## ADDENDUM 01

RE: **Addendum 01**  
 Project: **Downtown Sports Complex Site Development**  
 Bid #: **415-PW-041**

From: **Robert C. Spielman, P.E.**

## Decorative Stone

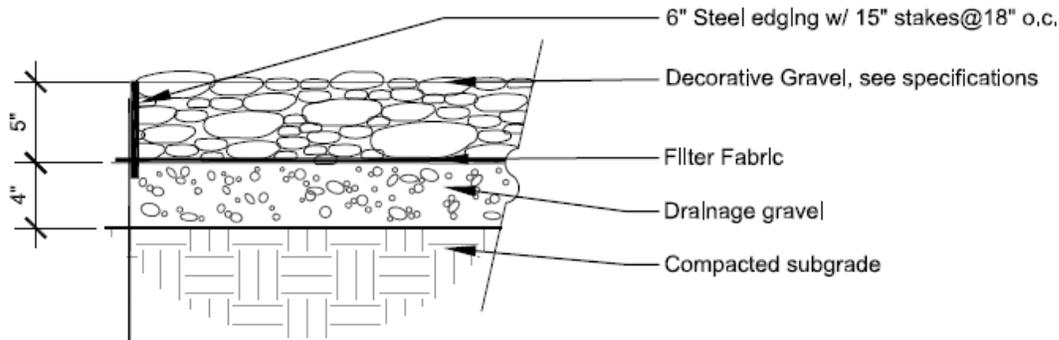
7. Are both decorative stone areas, behind shore rip-rap and between the segmented block wall and fence to include steel edging between stone and turf/ rip-rap? What is specified depth of drainage gravel and decorative stone?

**Yes, include edging. Decorative Stone should be as detailed below: 4" drainage gravel and 5" decorative stone.**
